## DESCRIPTIVE REPORT

*Registry No.* ..... H12024

*Sublocality* ..... Approaches to Port Madison and Shilshole Bay

**Revisions and Corrections Compiled During Office Processing and Certification**

Figure 2: 0.55-meter offset of 2803 data South of Shilshole

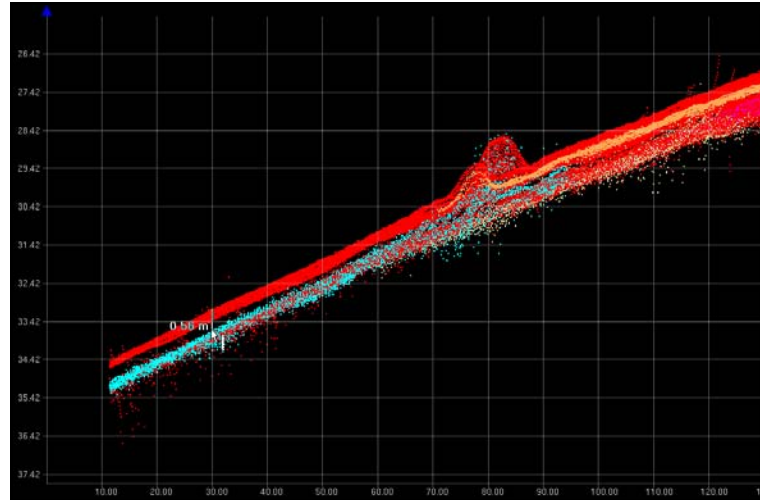
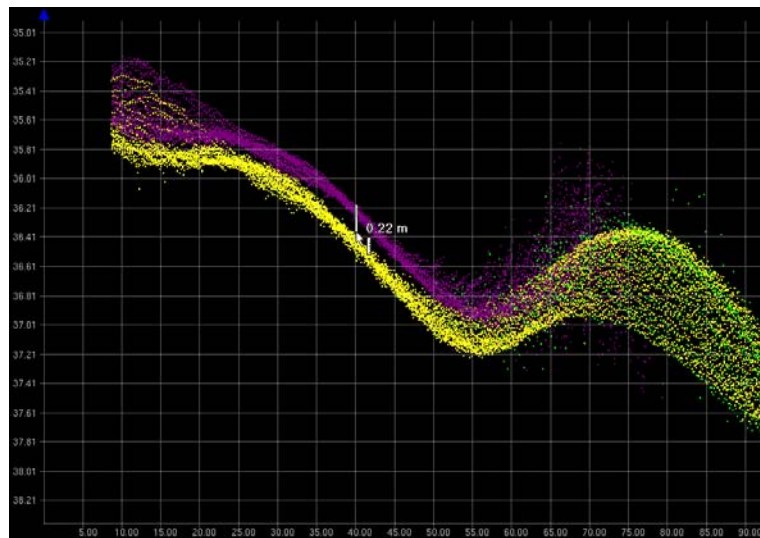
Data from H12024 exhibited vertical offsets throughout the survey area, which were attributed to tide modeling error.<sup>5</sup> Data from 2803 (RA-3) on April 16, 2009 (DN 106) had varying vertical offset from surrounding data with a maximum offset of 0.5-meters being evident in approximately 30-meters water depth, as shown in Figure 2. Data from 2804 (RA-6) exhibited similar varying offsets on April 11, 2009 (DN 101) with a maximum offset of approximately 0.2-meters evident in roughly 30-meters water depth, as shown in Figure 3. The varying nature of the offset leads to the conclusion that the vertical offset is largely due to tide error. Data from both 2803 (RA-3) and 2804 (RA-6) on these days show vertical offset between data acquired at different times of the day. Specifically, the greatest offset is evident in 2803 (RA-3) data between roughly 15:49 to 16:50 UTC with data from later in the day correlating with surrounding data better. Similarly, the greatest offsets in 2804 (RA-6) data are evident prior to 17:00 UTC with data from later in the day correlating with surrounding data better.

<sup>5</sup> The shoalest data is represented in the combined surface that was used as the basis for compilation. The data is adequate to supersede charted data in the common area despite the tide modeling errors.

Figure 6. Uncharted shoal on Chart 18447.

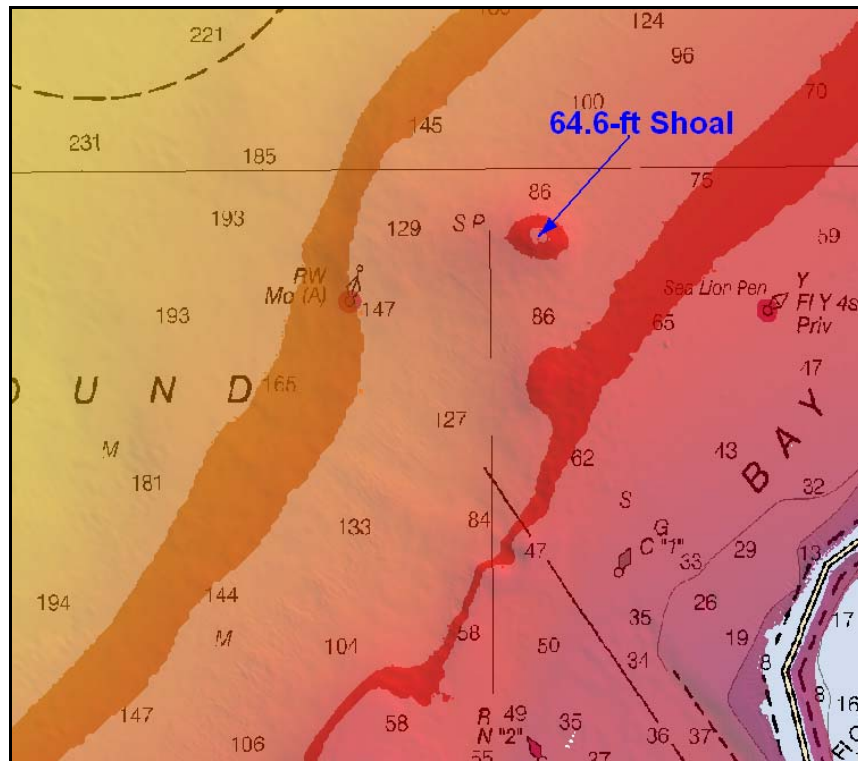
Depths from survey H12024 generally agreed with charted depths to within 10-feet and no significant discrepancies were noted with charted soundings. Most differences of greater than 5-feet were found in waters deeper than 200-feet and are thus not navigationally significant.<sup>18</sup> A shoal area at the entrance to Shilshole Entrance Channel in position 47° 40.97' N 122° 24.96' W is not denoted on chart 18447. The shoal has an approximate depth of 65-feet and is positioned between two 86-foot soundings, as seen in Figure 6.<sup>19</sup>

<sup>19</sup> A 64 ft sounding is included in the HCell.

Figure 7. Wreck Extending outside of Danger Circle on Chart 18447.

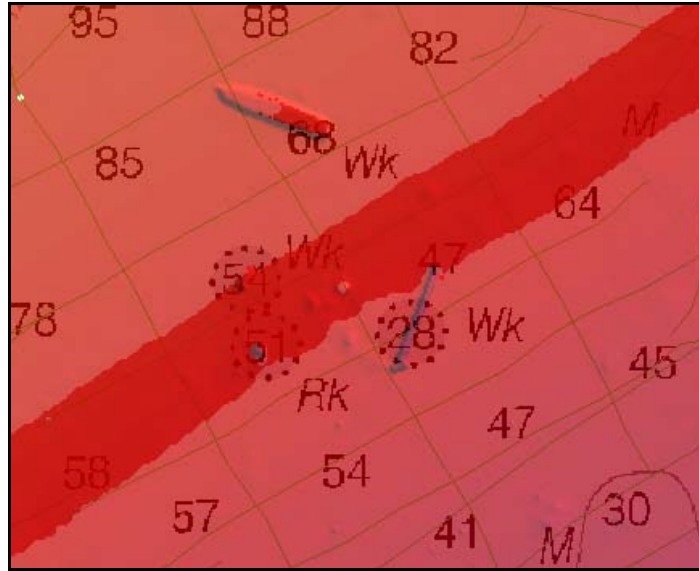
The charted wreck in position  $47^{\circ} 40.37' \text{ N } 122^{\circ} 25.32' \text{ W}$  extends beyond the wreck danger circle, as shown in Figure 7. The hydrographer recommends making this wreck an area feature on this large scale chart.<sup>23</sup>

<sup>23</sup> Do not concur. The shoalest point of the wreck is represented as a point feature in the HCell. The end of the wreck is represented by a sounding.

Figure 8. H12024 Pipeline Reposition.

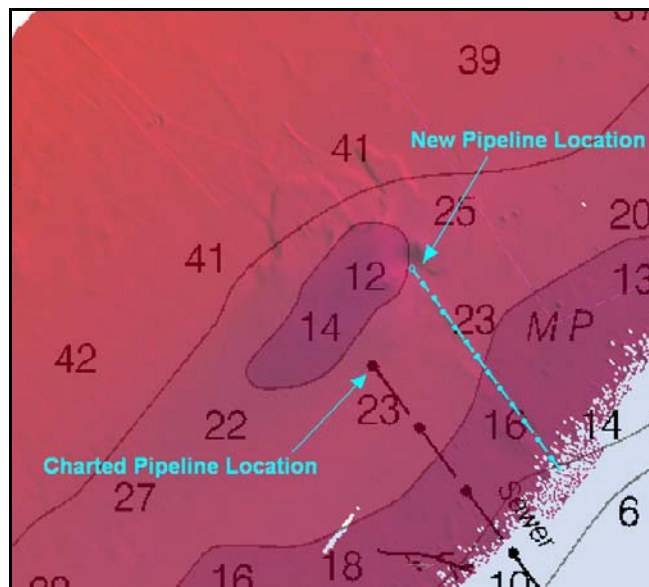
Survey H12024 includes several charted cable and pipeline areas. No visible indication of pipelines was evident in the MBES data in the pipeline area on chart 18447 immediately to

the West of the Ship Canal Railroad Bridge in approximate position 47° 40.0' N 122° 24.2' W. No visible indication of pipelines were evident in the MBES data in the pipeline areas on chart 18446 to the North of Meadow Point in approximate position 47° 42.1' N 122° 24.0' W. No visible indication of cables was evident in the MBES data in the cable areas running from the northern sheet limits to the southern sheet limits on the eastern side of the Vessel Traffic Separation lanes on chart 18447. The Hydrographer recommends retaining the cable and pipe areas as charted.<sup>34</sup> All charted pipelines, with the exception of those noted above, on charts 18446 and 18447 were noted in the MBES data and agree well with charted positions, with the exception of the charted pipe in approximate location 47° 40.2' N 122° 25.5' W which is located approximately 50-meters to the southwest of the charted location.<sup>35</sup> This new location for the charted sewer pipeline has been included in the H12024\_Final\_Feature\_File in the Caris Notebook session, as shown in Figure 8.

<sup>35</sup> The position of the new pipeline is included in the HCell as a \$LINES linear blue note.
